SUBJECT: Forwards requests for relief from inservice insp requirements of ASME Boiler & Pressure Code, Section XI due to impracticality of performing volumetric examinations on welds in several sys.

Re: Oconee Nuclear Station  
Docket Nos. 50-269, -270, -287

DUKE POWER COMPANY  
REQUESTS FOR RELIEF FROM ASME CODE SECTION XI  
INSERVICE INSPECTION REQUIREMENTS

3" DRAIN FROM DECAY  
HEAT REMOVAL

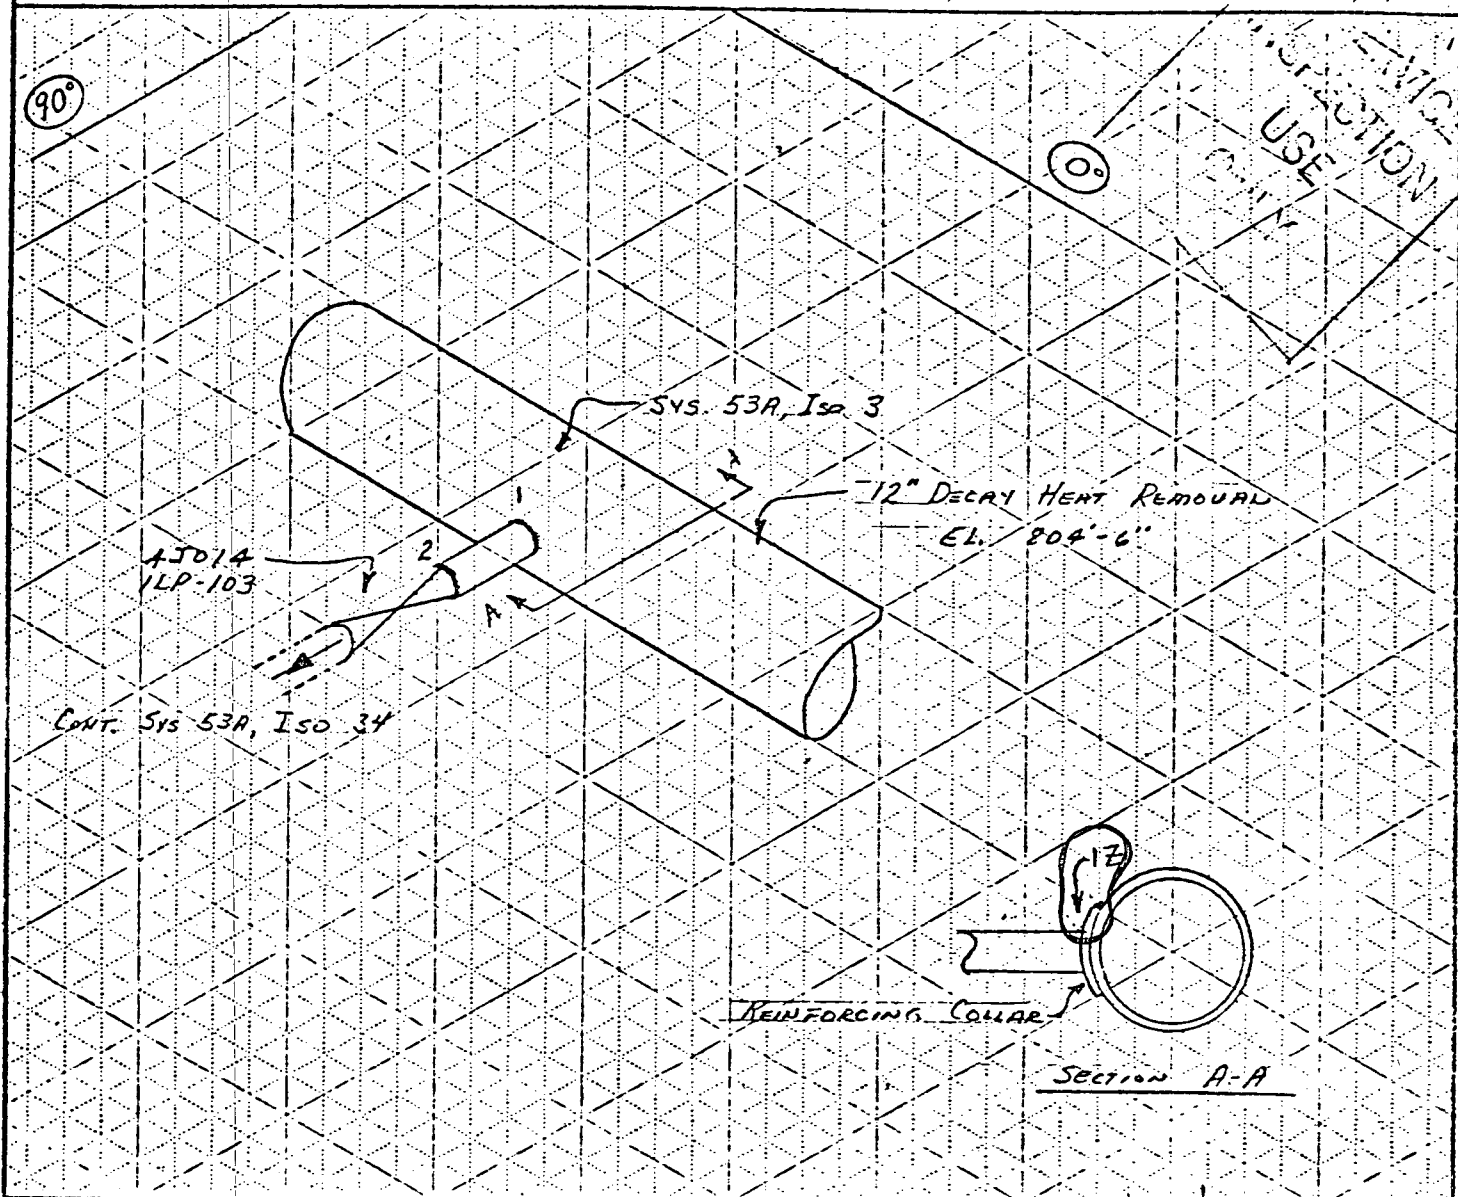
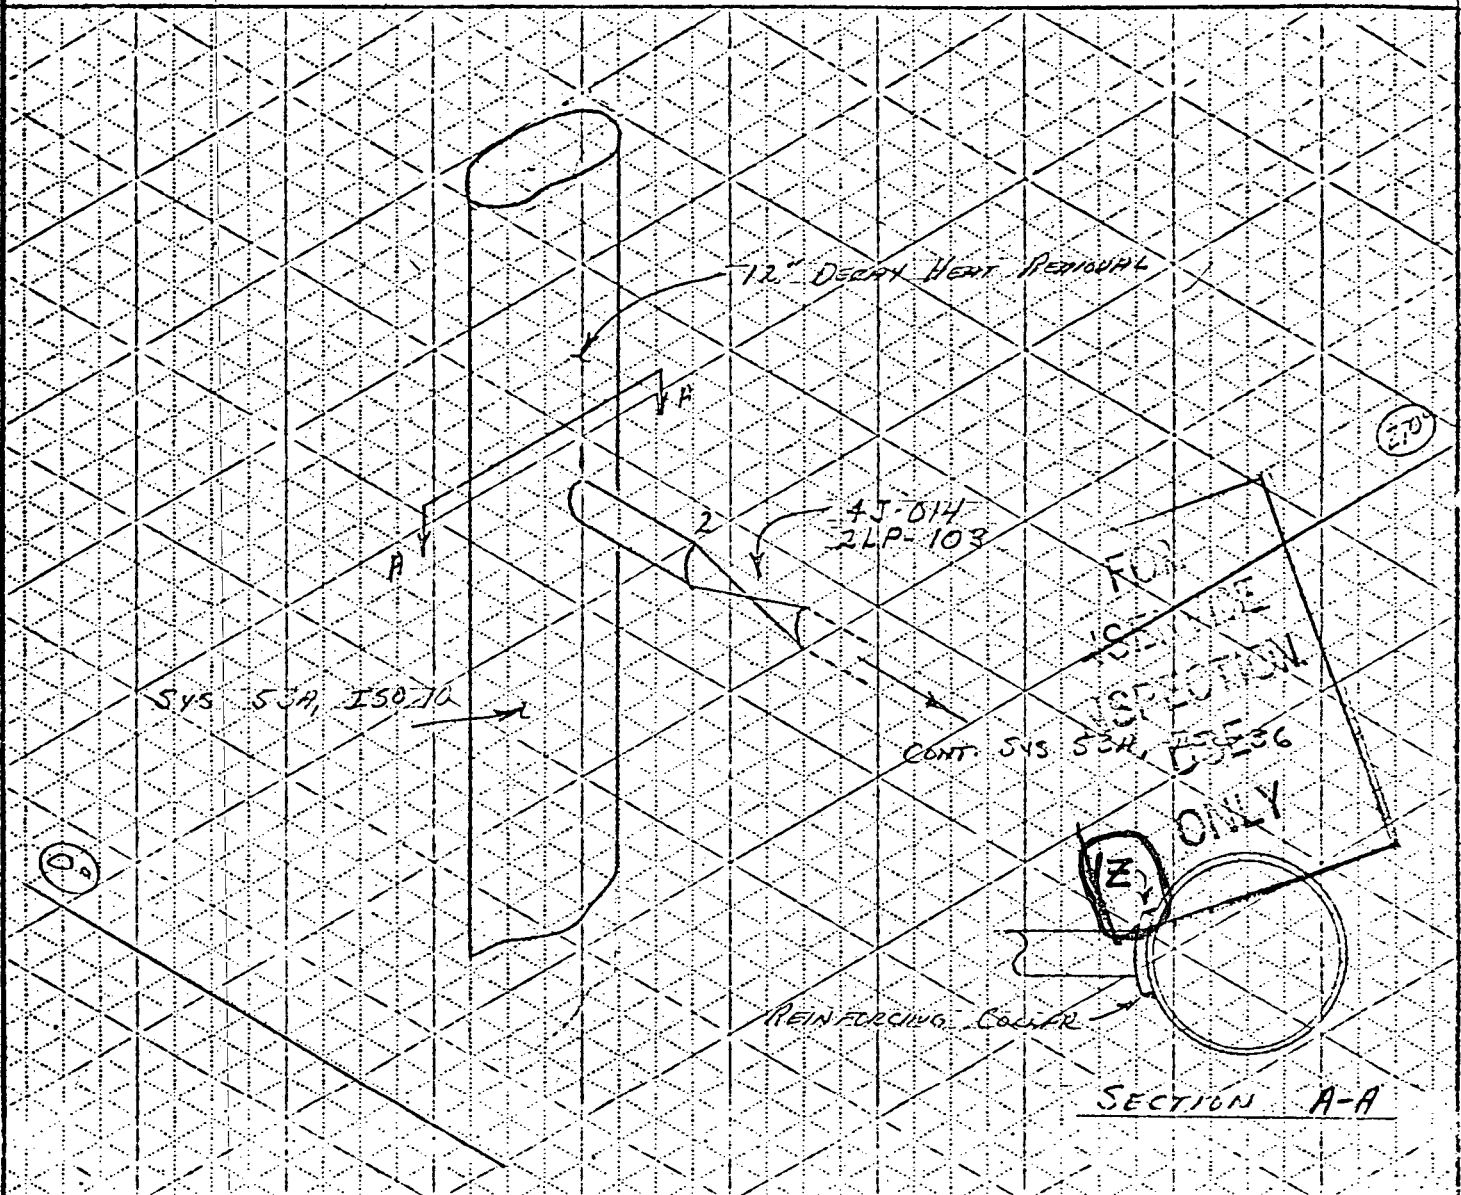
Welds 33-1, 35-1, and 37-1 are inaccessible due to the location of reinforcing collars. The reinforcing collar welds (welds 33-1Z, 35-1Z, and 37-1Z) were examined in accordance with the reference code.

Since welds 33-1, 35-1, and 37-1 are completely covered by the reinforcing collar, no alternate examination is possible.

ATTACHMENT D-1

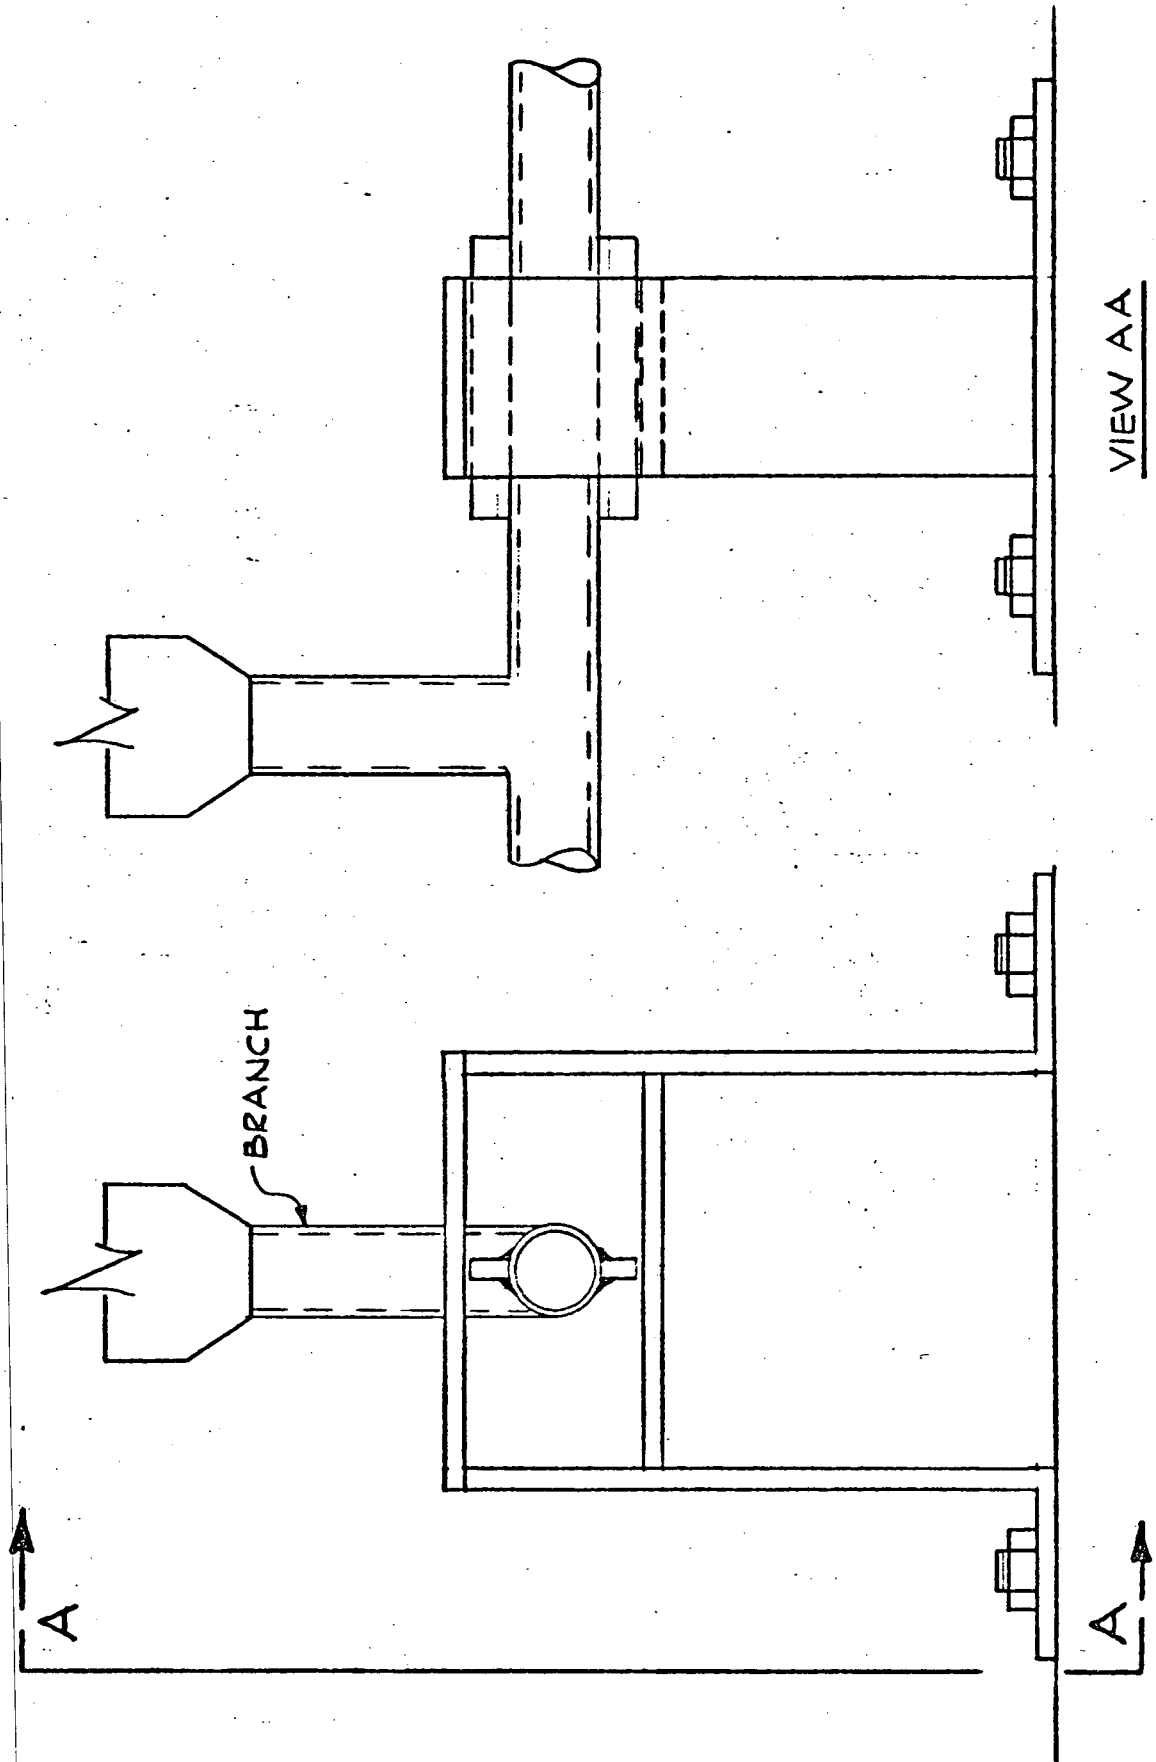
The geometry of welds 7Z and 33Z is such that a meaningful volumetric examination cannot be performed. Examination of the base metal is limited due to the restraining box that surrounds the attachment. Removal of the restraining box could result in damage to the pipe. Since the failure mode of this weld would be a surface phenomenon, the performance of a volumetric examination of the base metal would not result in increased assurance of safety. Attachment D provides sketches of the welds.

SUPPORT IS TYPICAL FOR WELDS 7 Z AND 33 Z

Surface examinations were performed in lieu of volumetric examinations.

ATTACHMENT A-2

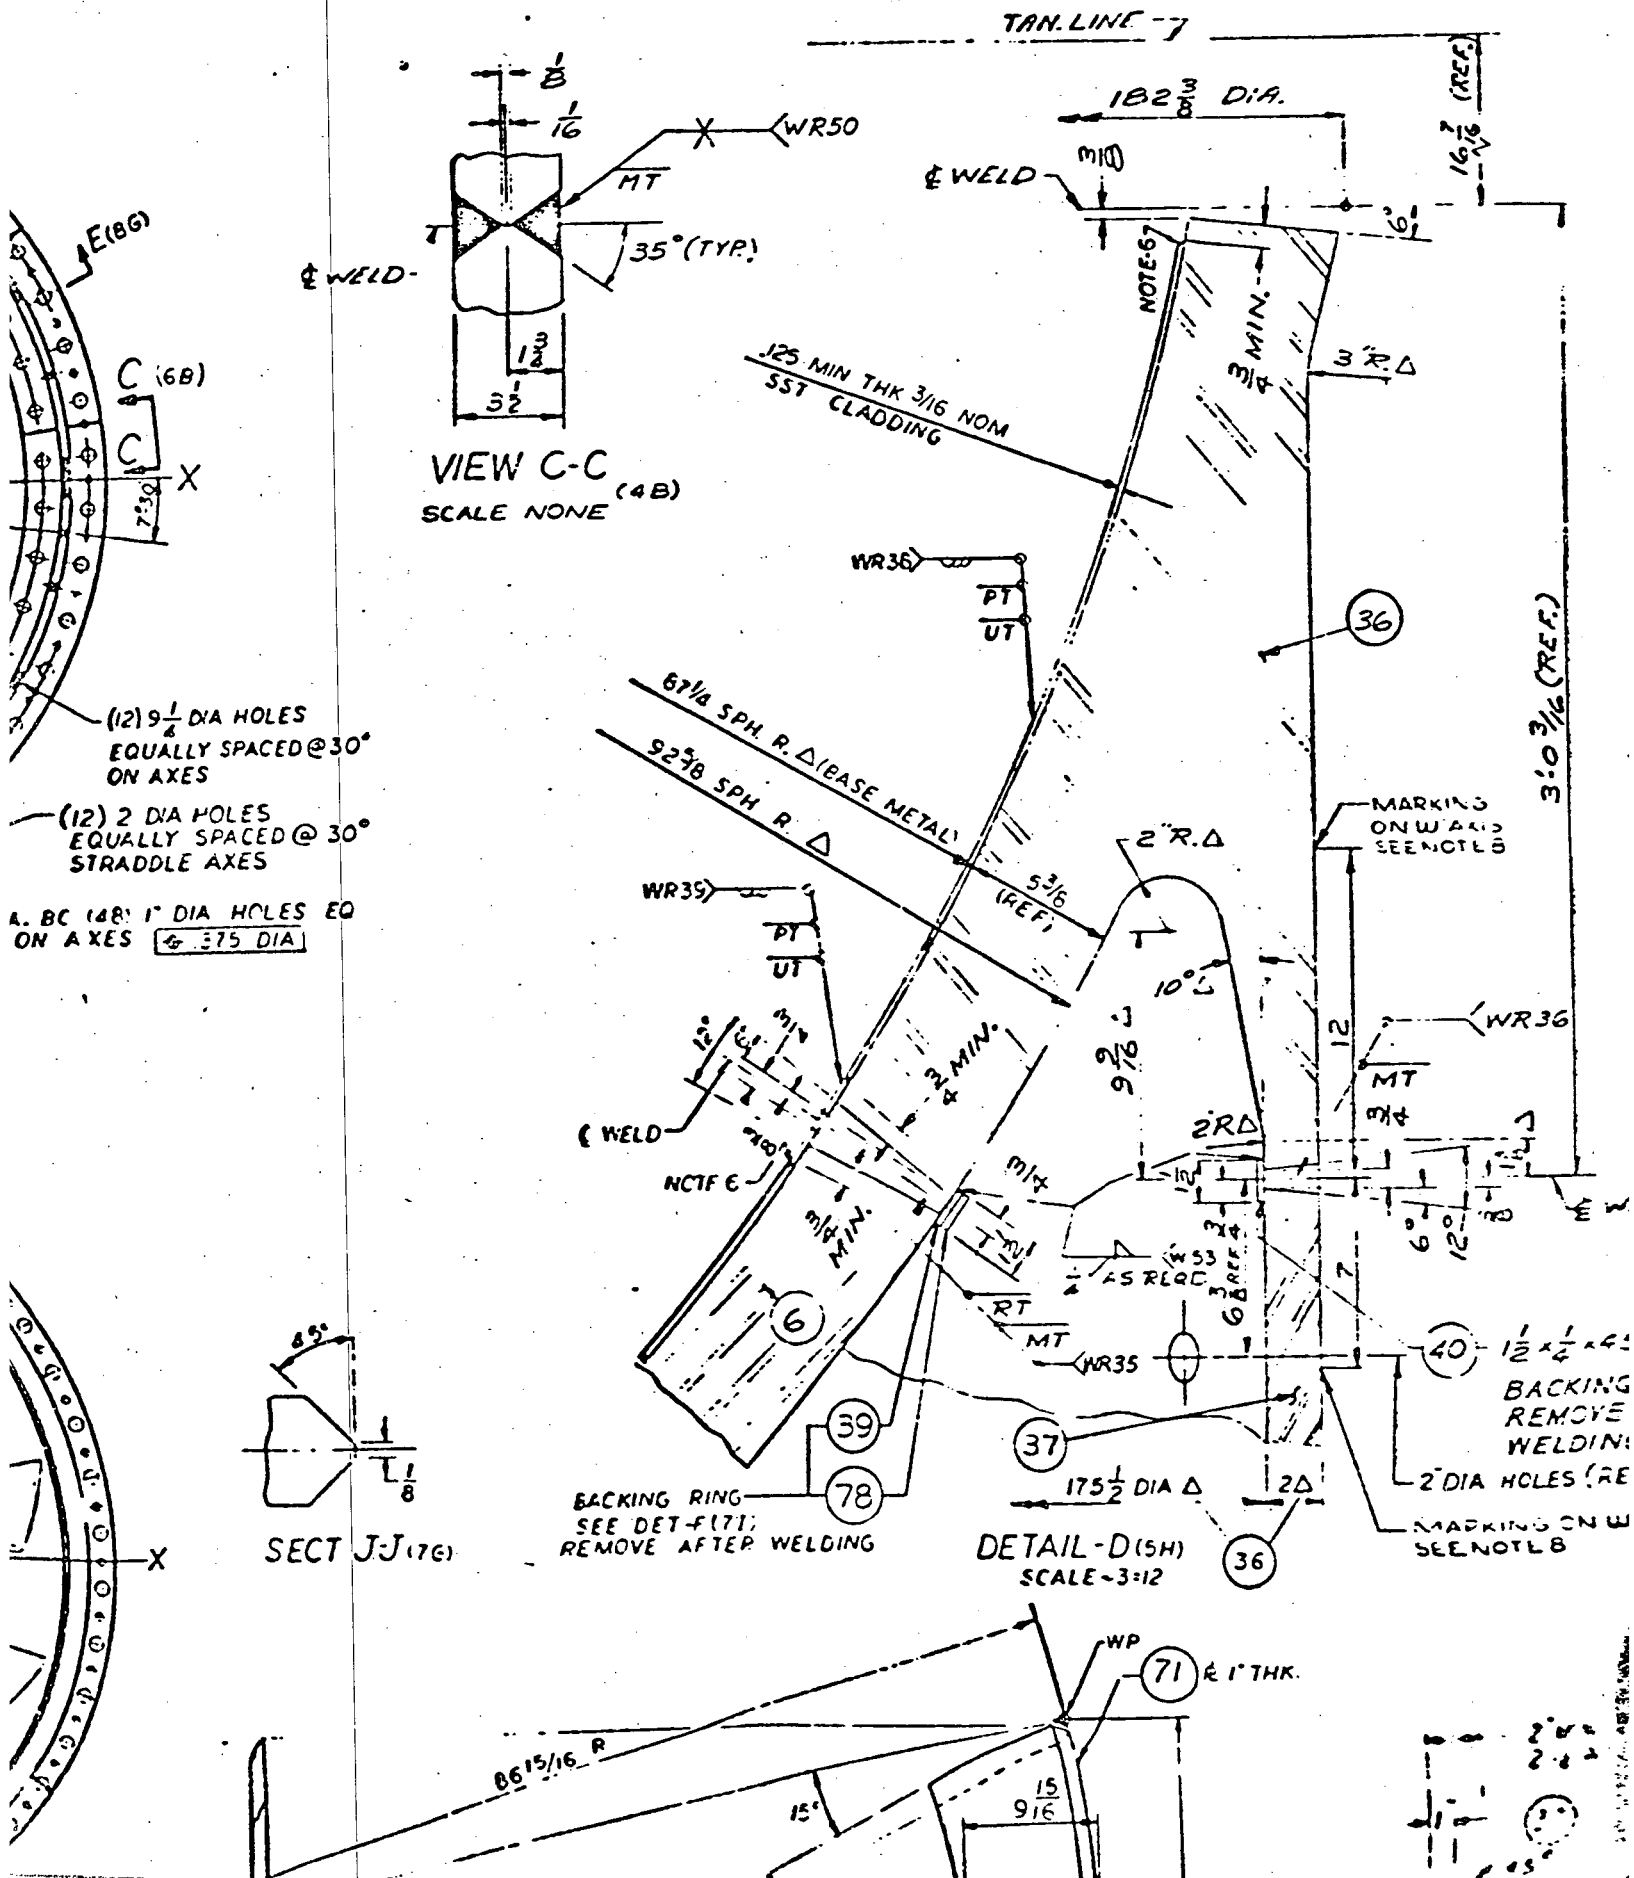
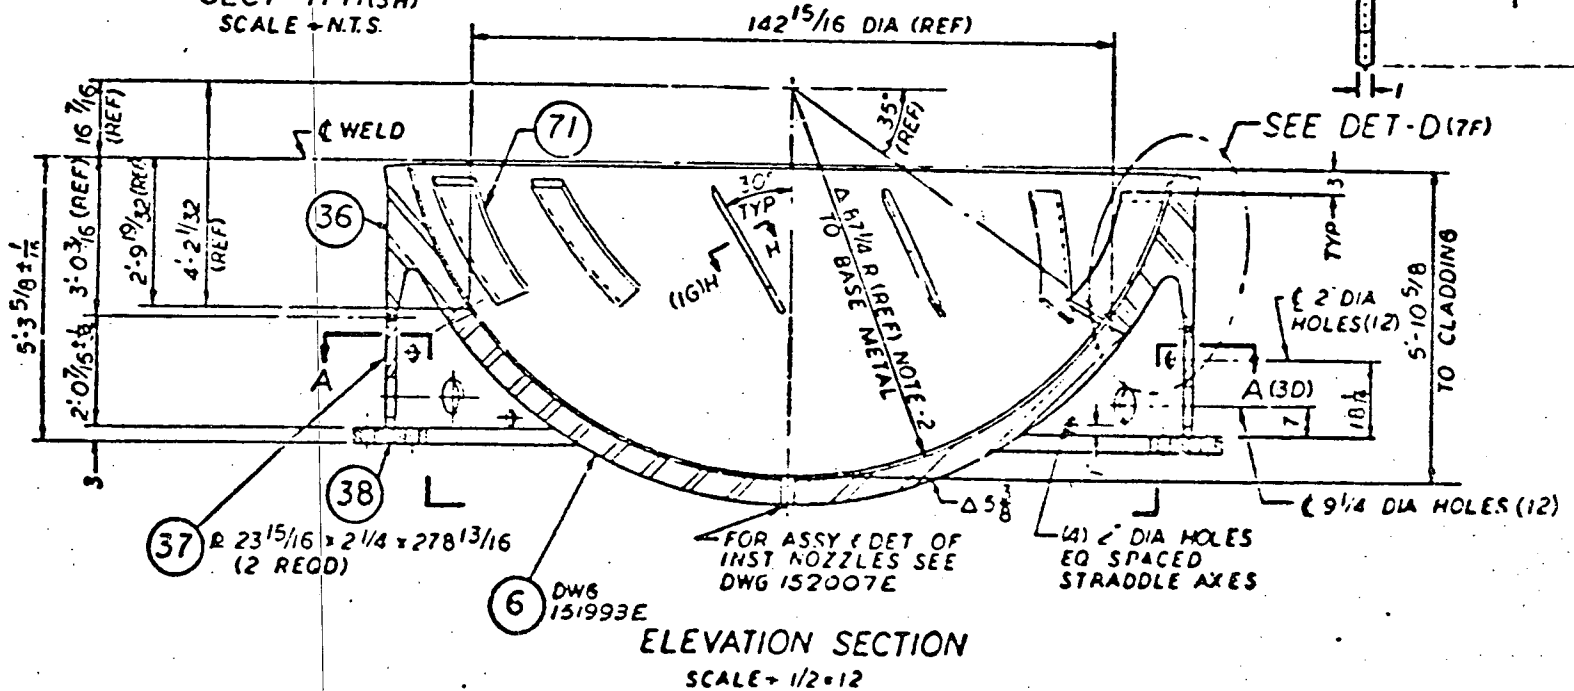
A volumetric examination cannot be performed due to dose rate considerations. The radiation level is 12 R/hr on the surface of the insulation in the vicinity of the weld, and it is estimated that the contact level at the weld is 20 to 25 R/hr.

Remote visual examination of the weld will be performed.

ATTACHMENT B-1

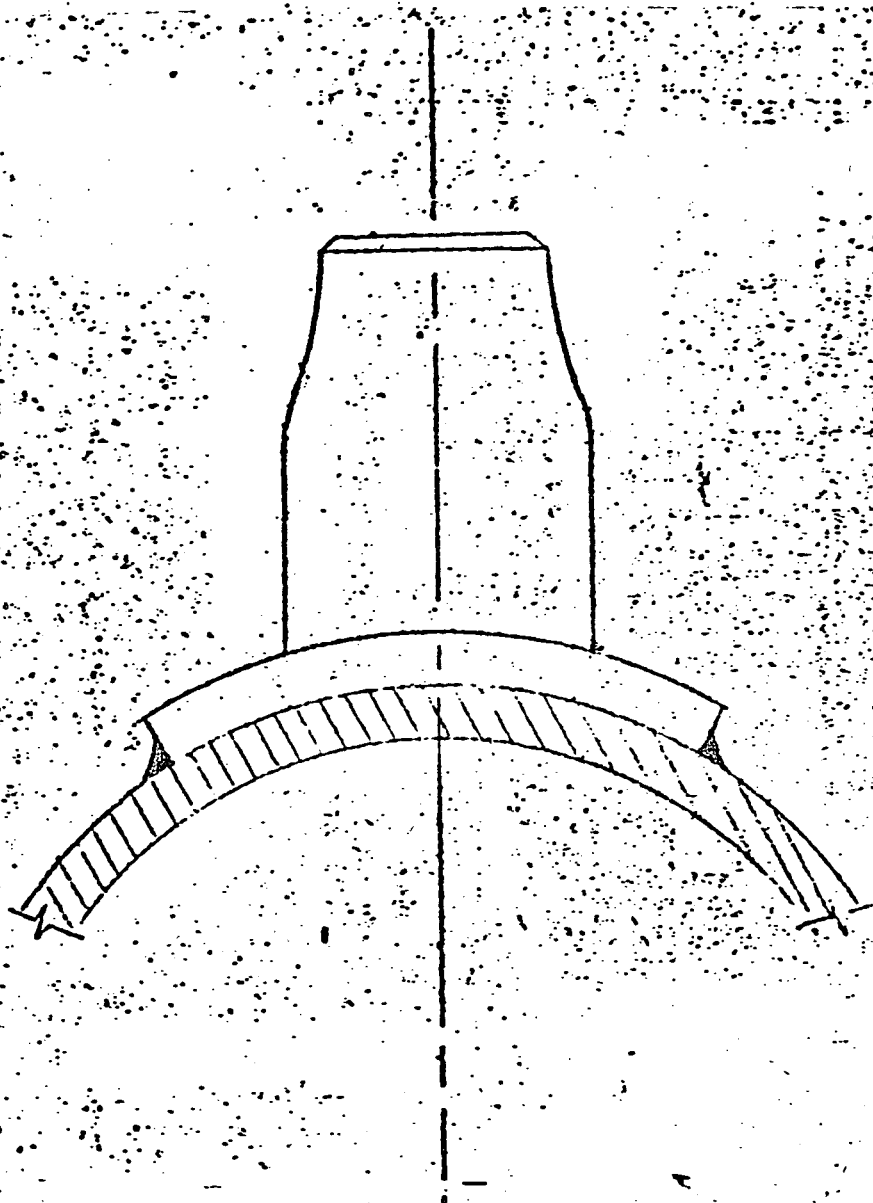
The welds listed are not accessible for volumetric examination due to the location of reinforcing collars (refer to the sketch in Attachment B).

TYPICAL COLLAR  
CONDITION

A surface examination is performed in lieu of the volumetric examination.
